**AGREEMENT NO. 20-DES-RFP-031
AMENDMENT NUMBER 02**

This **Amendment Number 02** (hereby changed from Modification to Amendment) is made on the **June 8, 2021** by the County and amends **Agreement Number 20-DES-RFP-031** ("Main Agreement") dated **September 22, 2020** between **Stantec Architecture, Inc.** ("Contractor") and the **County Board of Arlington County, Virginia** ("County").

Project Name and Location: Arlington Transit (ART) Operations and Maintenance Facility at 2629 and 2635 Shirlington Road

Re: Supplemental Change Order No. 1 - Geotechnical Engineering Services
Arlington County Transit (ART) Operations and Maintenance Facility
Shirlington Road
Arlington, Virginia
Terracon Proposal No. PJD205008

EXPLORATION PLAN

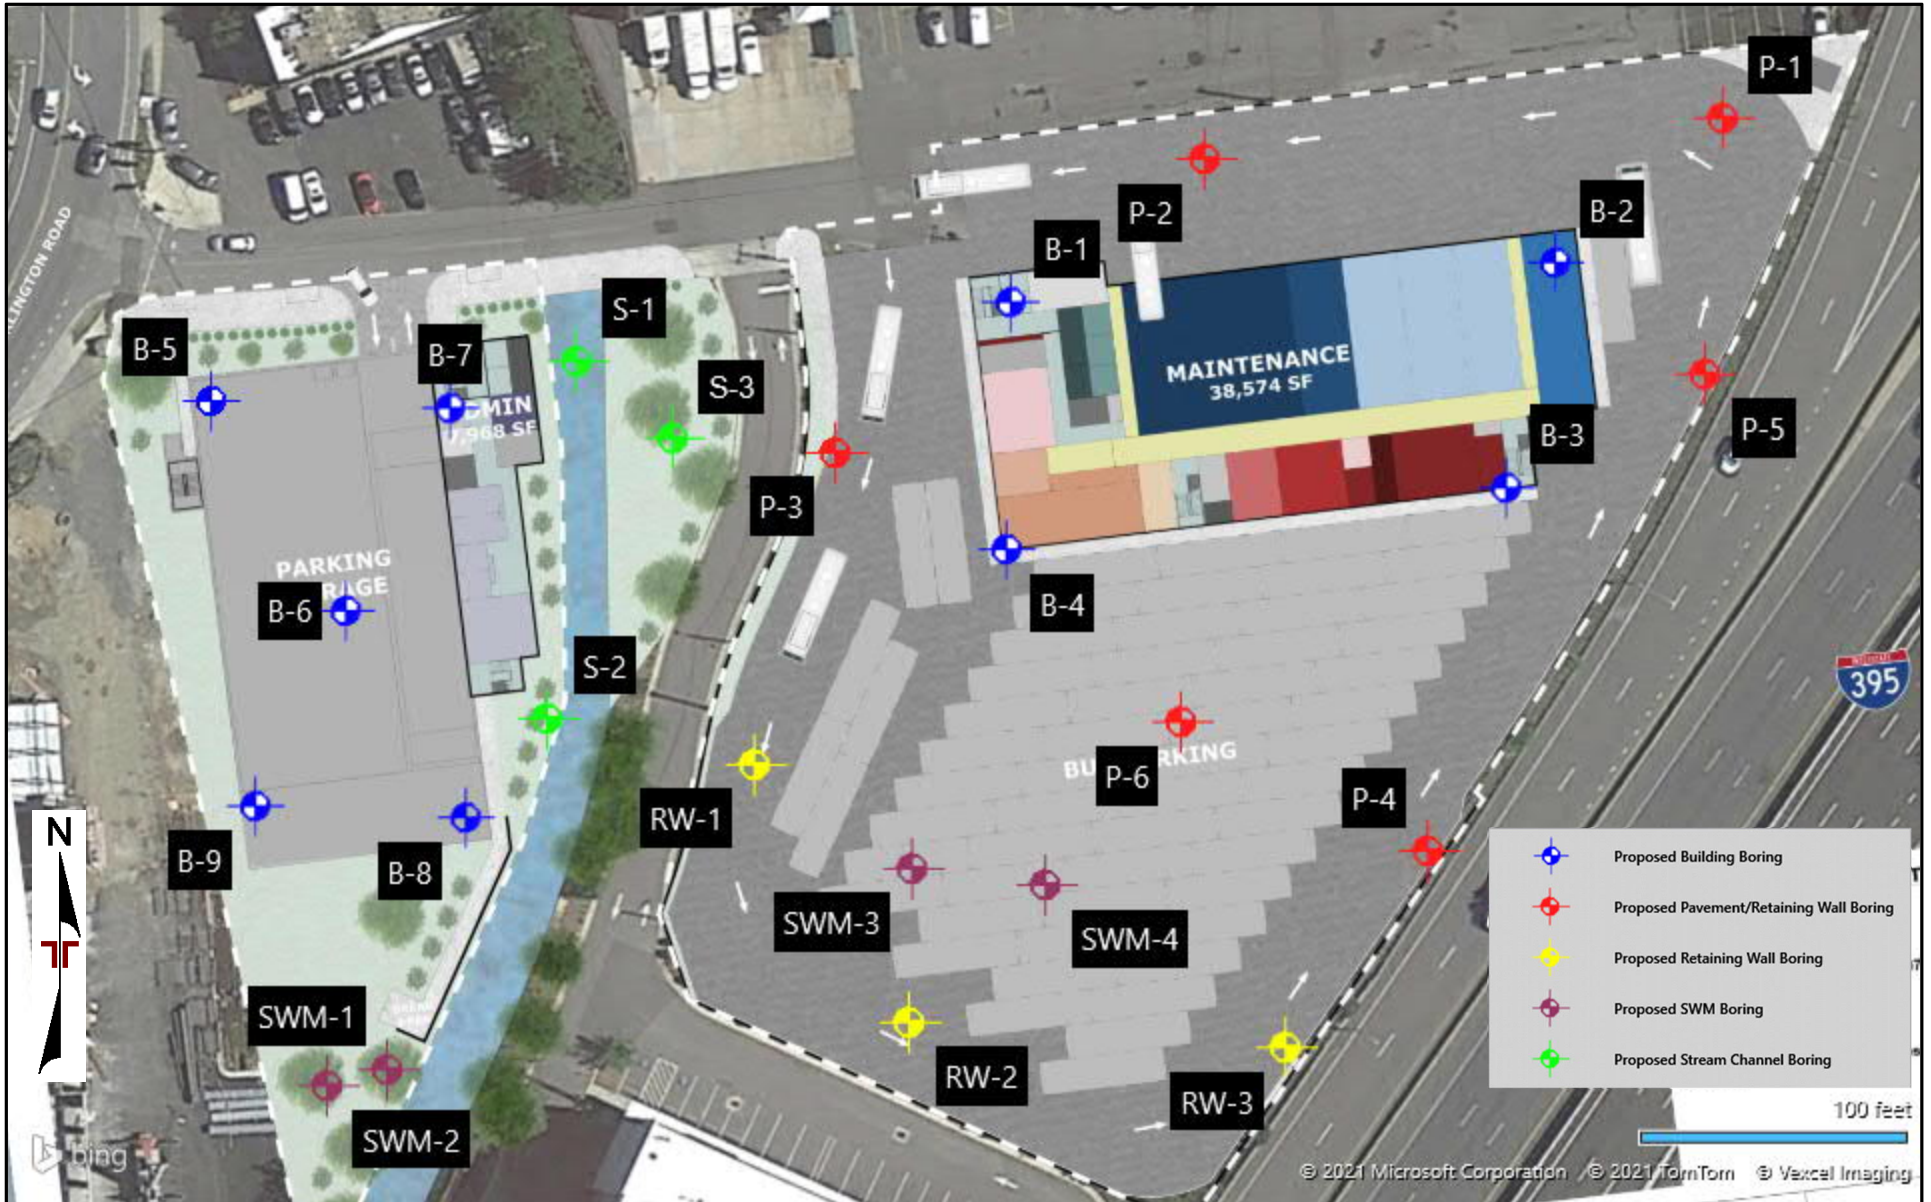
Number of Borings	Boring IDs (see Exhibit D)	Planned Boring Depth (feet) ¹	Planned Location
2	S-1 and S-2 ²	25 or auger refusal	Planned stream channel improvement area / existing retaining wall area
1	S-3 ³	20 or auger refusal	Planned stream channel improvement area / existing retaining wall area
2	SWM-3 and SWM-4 ⁴	15 or auger refusal	Planned stormwater management areas
3	RW-1, RW-2, and RW-3 ⁵	15 or auger refusal	Planned south retaining wall area

1. Below ground surface.
2. Previously 15-foot borings increased to 25 feet due to concerns for existing retaining wall.
3. Previously 15-foot boring, moved and increased to 20 feet due to concerns for existing retaining wall. Original S-4 boring deleted from project scope.
4. Includes an offset boring drilled to a maximum depth of 10 feet each, which will be tested for in-situ infiltration according to the applicable local regulations.
5. Additional retaining wall borings added due to proposed maximum height of the southern wall. We understand that wall heights are not to exceed 8 feet in these areas.
